Hydrology Consultation Report for CAPC: Objection to Planning Application for CA12 Development

25/00778/FULMAJ

Strong objection on flooding grounds.
Flood risk to Rivers Estate, Thatcham.
Flood risk to Kennet and Thames Valley.
Alteration of Flood Detention Ponds.
Sewer out-flows.
Misleading information
Not using the Correct Flood Risk Zoning rules.

Diagram 1 - Development Area shown as a FLOOD ZONE RISK 2 & 3 status on most recent Environmental Flood Map March 25th 2025. [Map – Flood map for planning – GOV.UK](https://flood-map-for-planning.service.gov.uk/map?cz=451311.6,168388.8,17.688284)

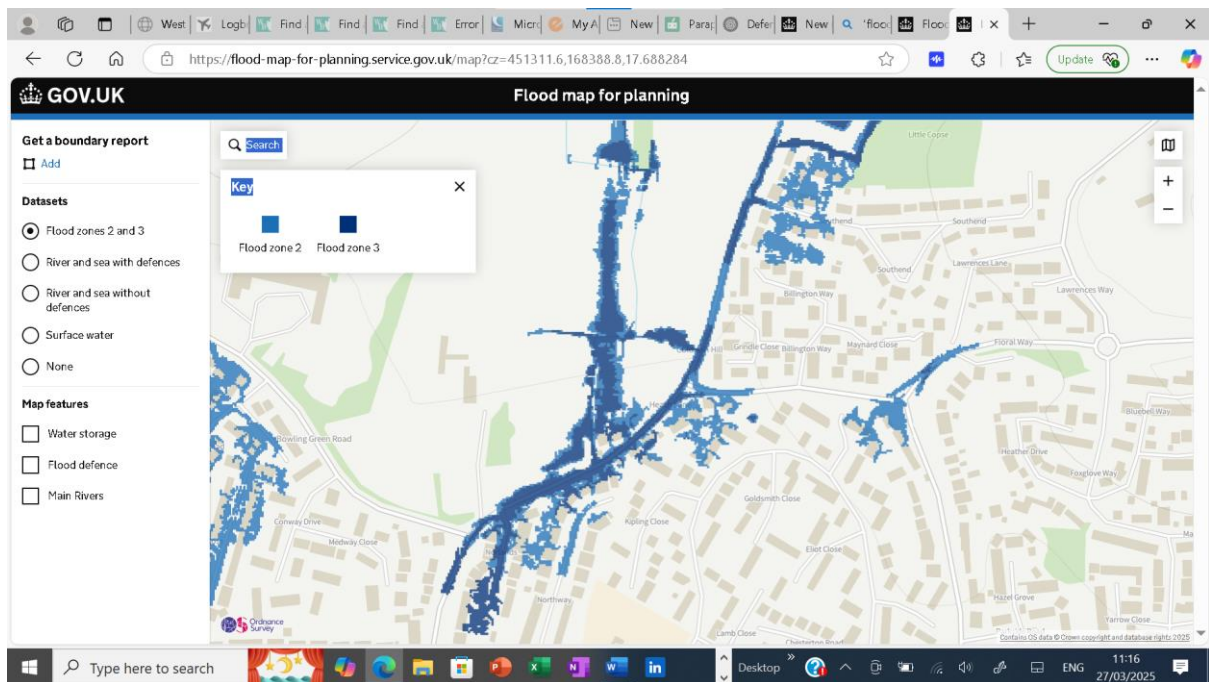
- **Development Area is designated Flood Risk 2 & 3 in published mapping environmental report updated March 25th 2025 which is not acknowledged nor properly considered by the developer – see diagram 1 below**

Gov.UK Flood map for Planning

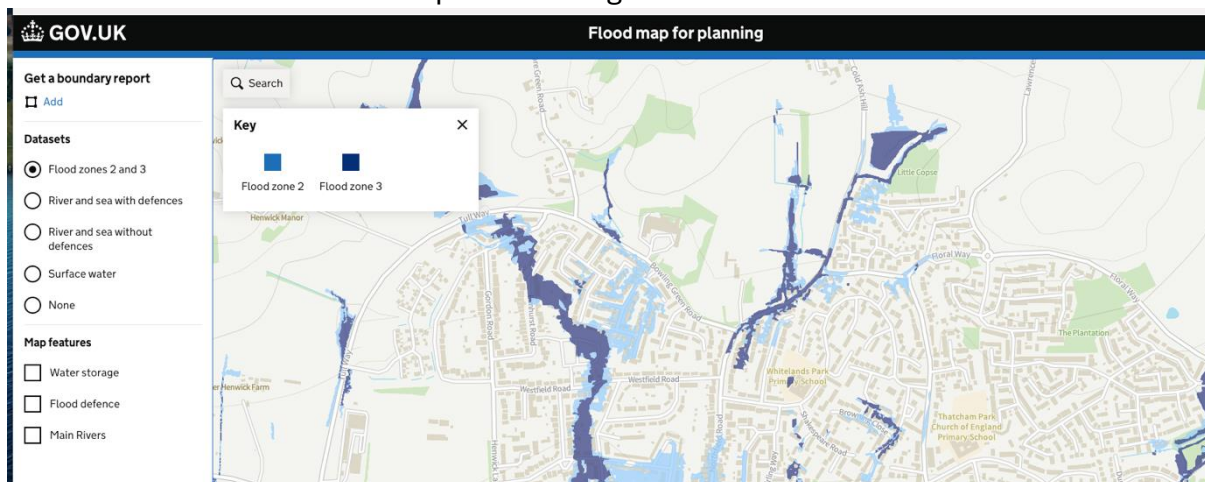
The Developer water calculation and assumption are based on the development site being in Flood Risk Zone 1, the lowest risk of flooding. The Government Flood map for planning, zones large key construction areas in Flood Risk 2 and 3. Flood Risk 3 is the highest level of Flood Risk and therefore needs far greater detailed analysis.

The developer’s prediction, assumption and calculations are all based base on the minimum amount of rain and surface water flows. Developer MUST USE Flood Risk 3 forecasting modelling data and not the low Risk they are using. The developer also needs to add-in to the calculations of the underground water levels and movement.
